STAFF RECOMMENDATION 1701 Fifth Avenue North January 20, 2016

Application: Demolition; New construction – infill, outbuilding; Setback determination

District: Salemtown Neighborhood Conservation Zoning Overlay

Description of Project: The applicant proposes to demolish the existing house and construct a new building with a footprint of two thousand, seven hundred square feet (2700 sf) and a detached outbuilding with a five hundred, seventy square foot (570 sf) footprint on the property.

① SITE PLAN
1" = 20'-0"

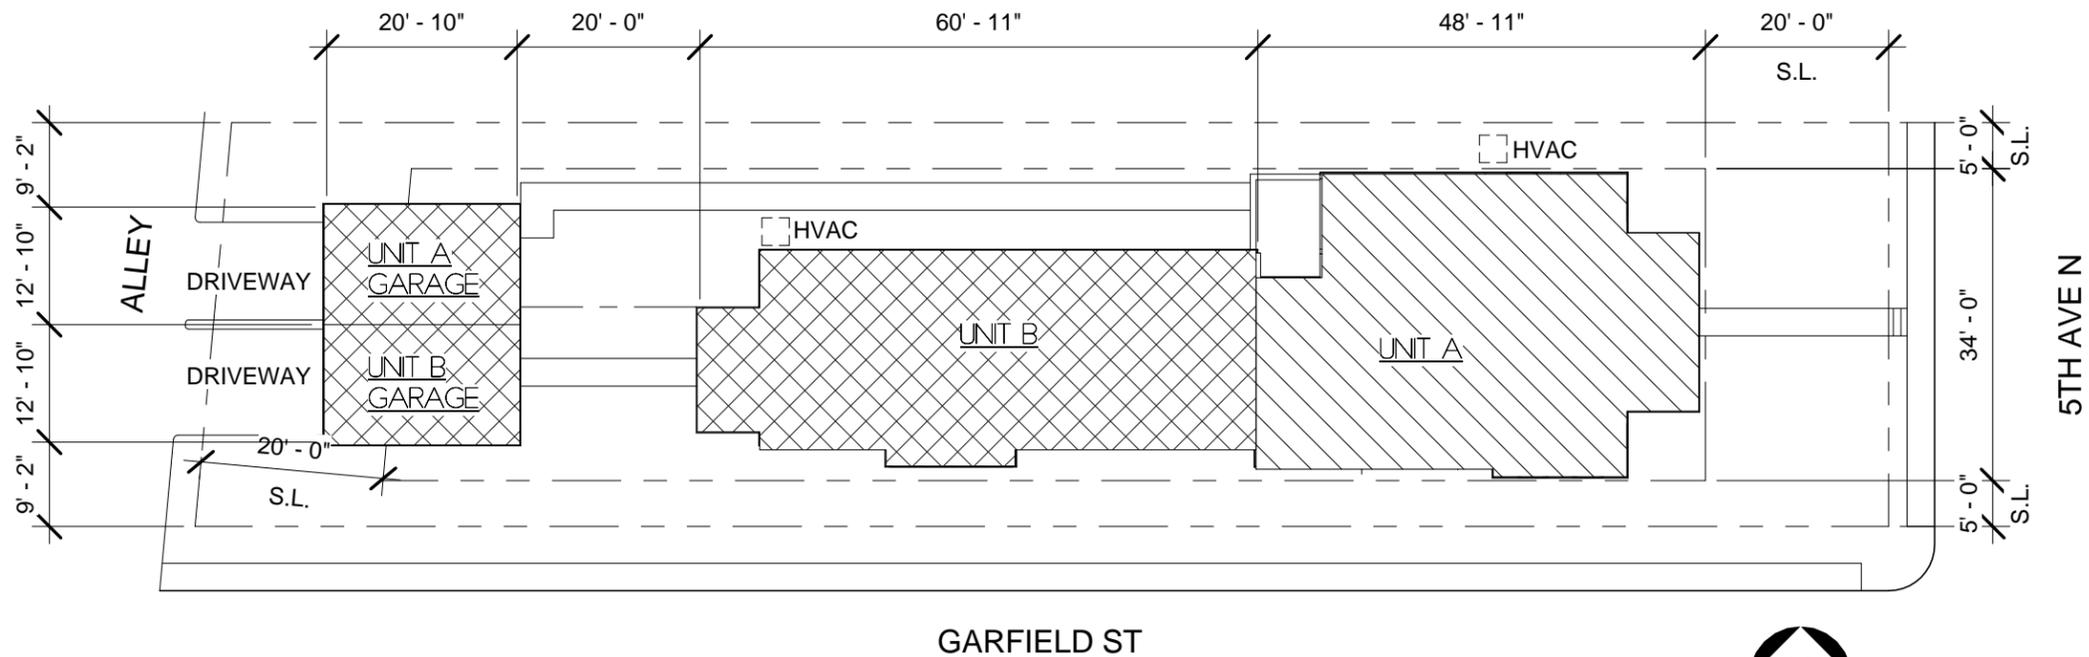
Setback & Rhythm of Spacing: The front of the building is proposed to have a twenty-foot (20') front setback. The setback of the adjacent historic is not known. Staff recommends that the front setback of the new building match the front setback of the adjacent building. The building will be more than fifty feet (50') in from the rear of the property.

The left and right setbacks will be five feet (5') on both sides. Staff finds these setbacks to be appropriate as they are typical of comparable historic houses on corner lots. However, the standard setback requirement for the side street-facing elevation is ten feet (10'). The building across Fifth Avenue North also has a minimal side setback. Because the proposal is compatible with other corner lots and because the lot is six feet (6') narrower than the typical lot, staff finds the proposed setbacks to be appropriate and to meet section II.B.1.c of the design guidelines.

Outbuildings: The application includes a detached outbuilding behind the house, accessed from the alley at the rear. The building will be separated from the house by twenty feet (20') with side setbacks of nine feet (9') on both sides. The standard setback for the street-facing side of an alley-accessed outbuilding is ten feet (10'). Because the lot is six feet (6') narrower than the typical surrounding lot, and because the house would have a side setback of only five feet (5'), Staff finds the proposed setbacks to be appropriate.

- The front setback shall match that of the adjacent historic house; and
- Staff shall approve roof color, window and door selections prior to purchase and installation;

① EAST (5TH AVE N) ELEVATION
3/32" = 1'-0"

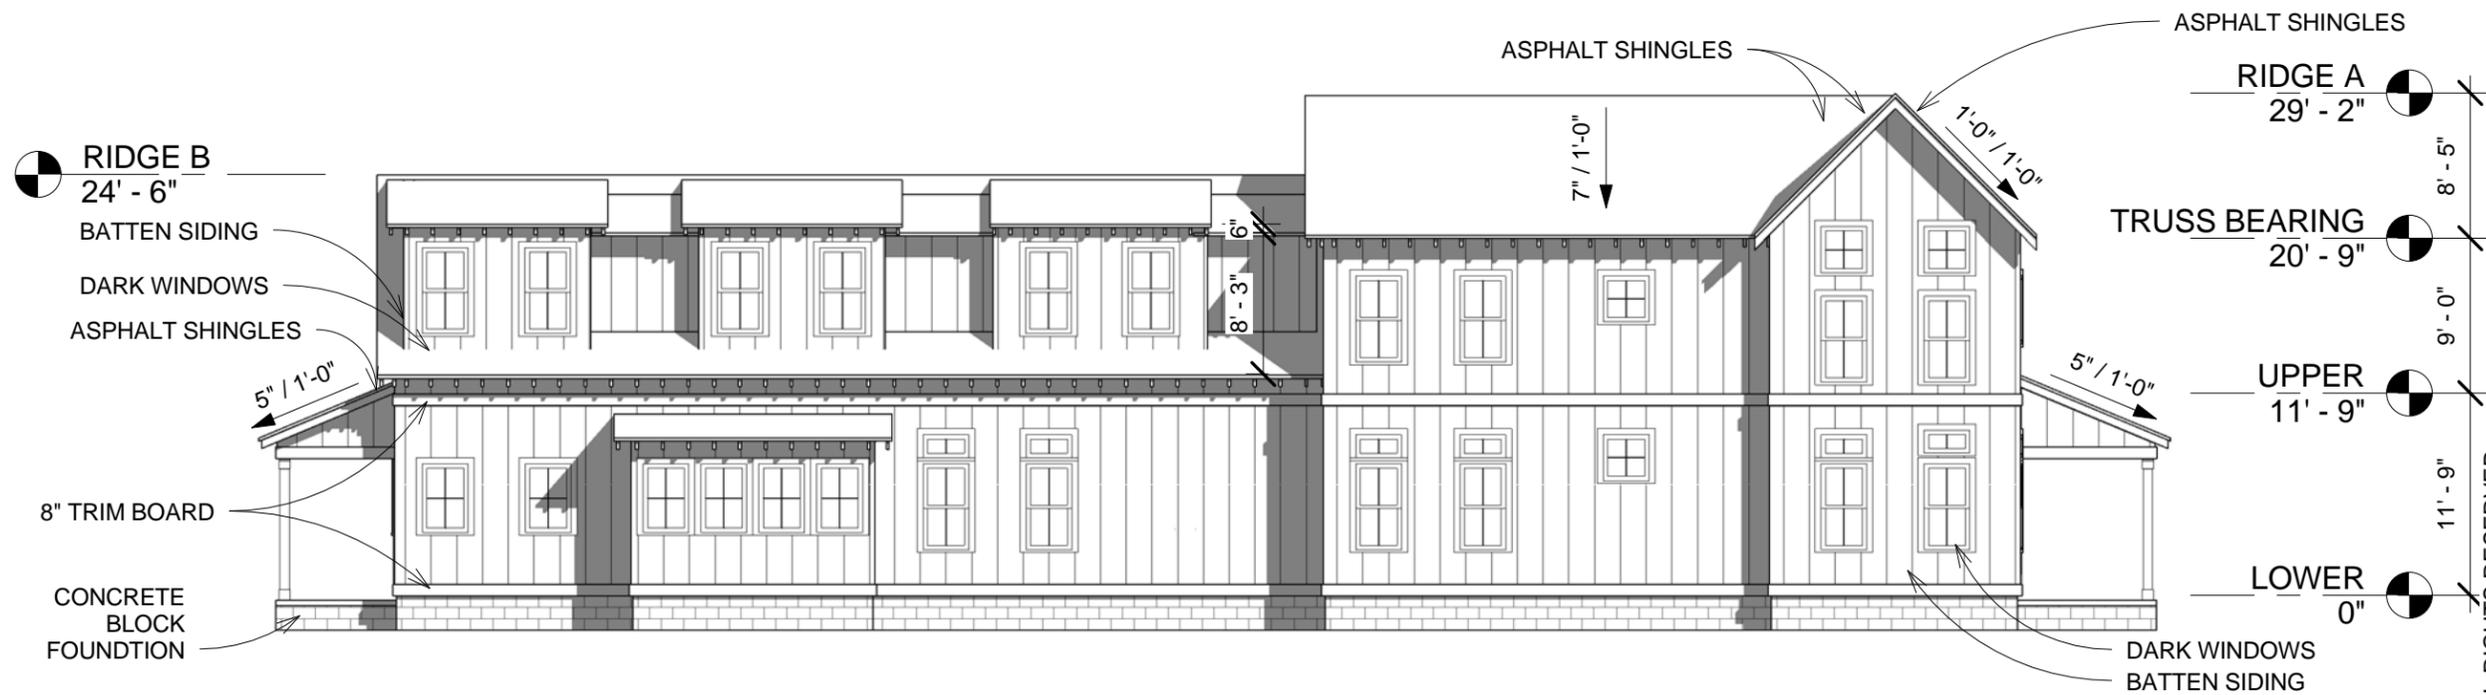
Height & Scale: The new building will have two primary components, each correlating to one unit of the duplex. The front component will be two-stories tall with a form of a side-gabled house with a rear-facing wing. The roof height will be thirty-one feet (31') at the ridge with an eave height of twenty-three feet (23'). This section of the building will be thirty-three feet (33') wide at the front and extend back forty feet (40') where it intersects with the rear component. The building will have an eight foot (8') deep projecting porch roof in the center of the front façade.

Materials: The exterior walls of the new building will be clad with cement-fiber board-and-batten siding. The trim will also be cement-fiberboard. The foundation will be split-faced concrete block and the roof will be asphalt shingles. The roof color is not indicated, so staff asks to approve it prior to purchase and installation. The window and door materials are not indicated, so Staff also asks to approve their selection prior to purchase. Porch roofs, posts and floors? With the staff's approval of the roof color, and the window and door selections, staff finds that the known materials meet section II.B.1.d of the design guidelines.

Proportion and Rhythm of Openings: The windows on the proposed infill are all generally twice as tall as they are wide, with the upperstory windows shorter than those on the first story. This is compatible with the proportions on windows on historic two-

① SOUTH (GARFIELD ST) GARAGE ELEVATION
3/32" = 1'-0"

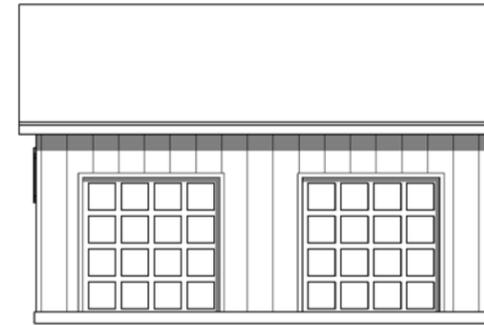
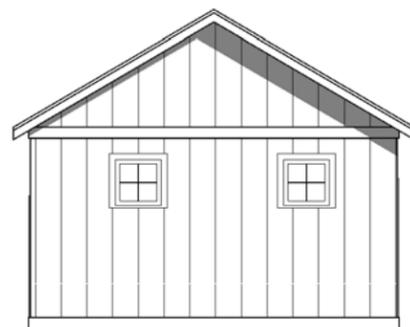
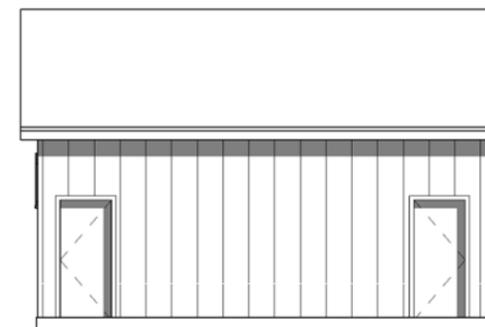
The footprint of the outbuilding will be five hundred, twenty square feet (520 sf), with two rear-facing vehicle bay doors. The roof will be eighteen feet, four inches (18'-4") tall with an eave height of eleven feet, nine inches (11'-9"). The exterior materials will match those of the principal building.

1 Roof Plan
1/16" = 1'-0"

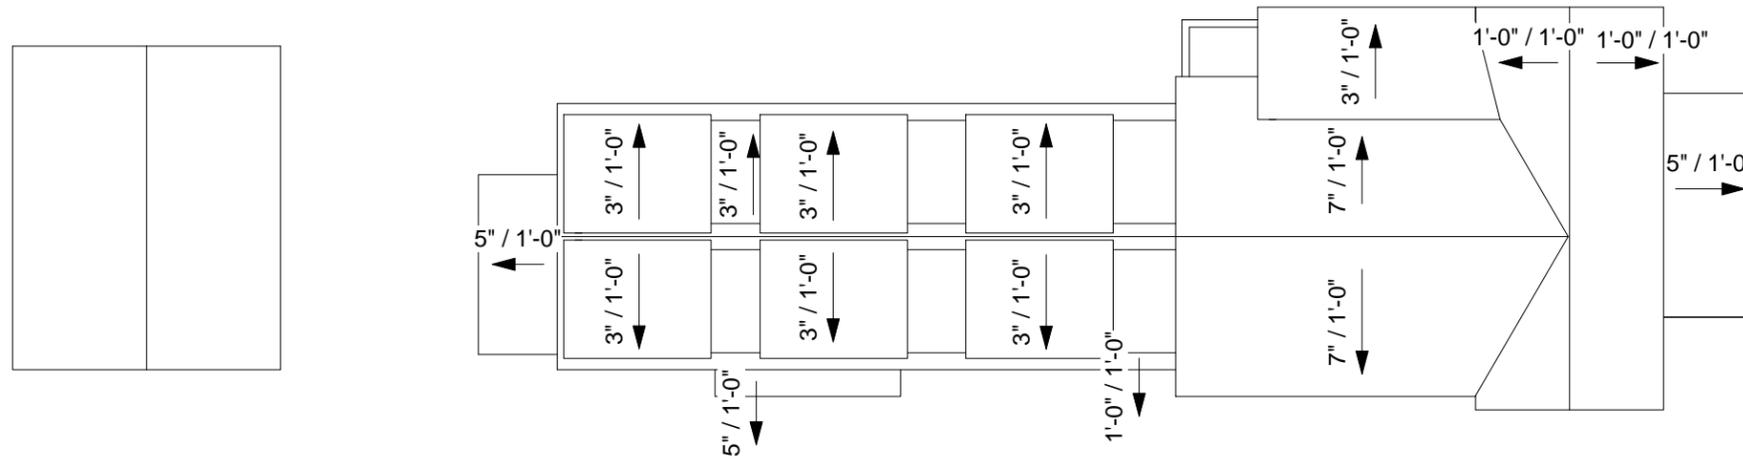
Roof form: The front component of the building will be a side-oriented gable with a 12:12 pitch. From the ridge of this gable extending back will be a rear-oriented gable with an 8:12 pitch, finally stepping down above the rear component to have 12:12 pitched gable with 3:12 pitched roofs on the dormers. While contemporary in their configuration, these roof forms are compatible with the roofs historic houses in the surrounding area, therefore staff finds that the project meets section II.B.1.e.
